Subject: Responses to Comments
HPMC Building Project Addendum

HPMC Building Project Addendum

Response to Comments from Adams Broadwell Joseph & Cardozo, dated October 18, 2021

Photo above: Illegal modular office buildings operated by Hollywood Presbyterian site.

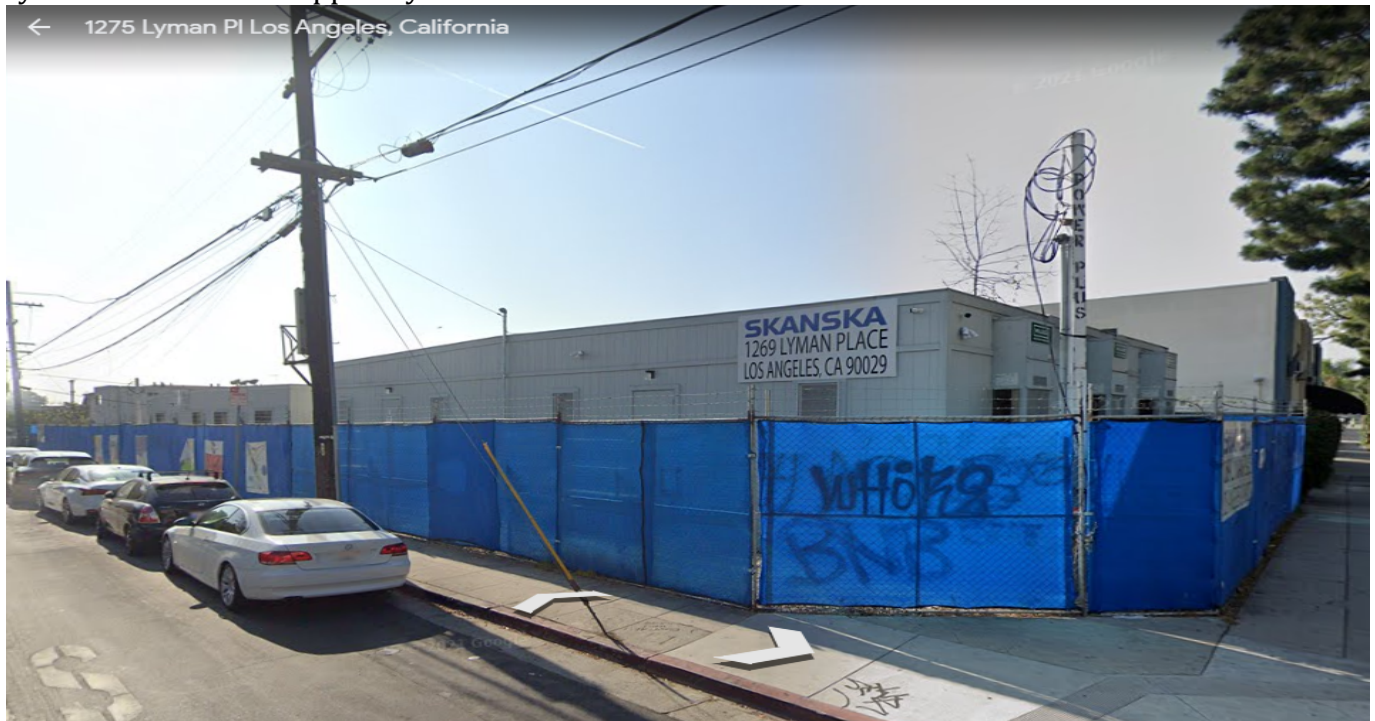
The Director's approval was appealed to the Central Area Planning Commission, which denied the appeal at its July 10, 2018 meeting. The century-old duplexes were quickly demolished, but instead of abiding by its conditions of approval, Hollywood Presbyterian Hospital has for 3 years illegally used the dirt lot for modular construction office buildings, which are surrounded by a chain link fence topped by barbed wire.

This eyesore was issued an Order to Comply in 2019 by LADBS. Hollywood Presbyterian has ignored this order, and the City has done nothing to enforce it.

Photo above: Illegal modular office buildings operated by Hollywood Presbyterian site.

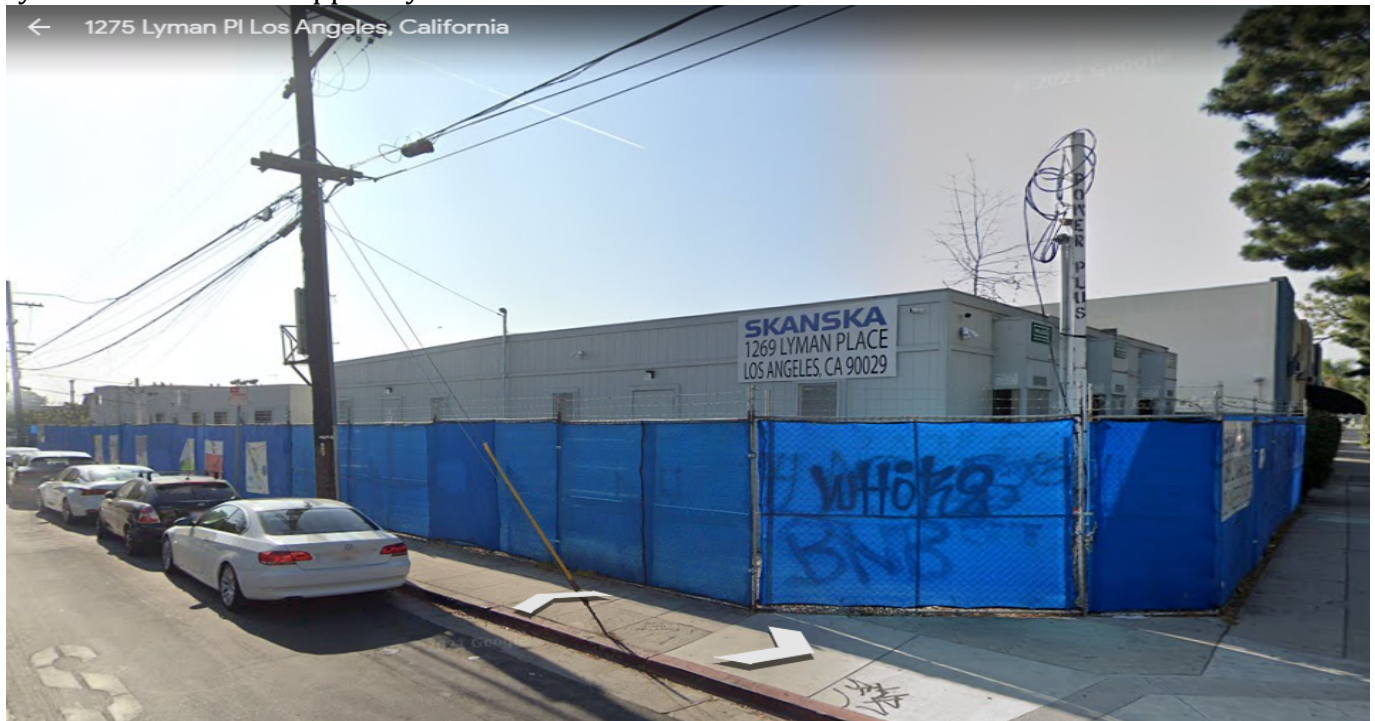
The Director's approval was appealed to the Central Area Planning Commission, which denied the appeal at its July 10, 2018 meeting. The century-old duplexes were quickly demolished, but instead of abiding by its conditions of approval, Hollywood Presbyterian Hospital has for 3 years illegally used the dirt lot for modular construction office buildings, which are surrounded by a chain link fence topped by barbed wire.

This eyesore was issued an Order to Comply in 2019 by LADBS. Hollywood Presbyterian has ignored this order, and the City has done nothing to enforce it.
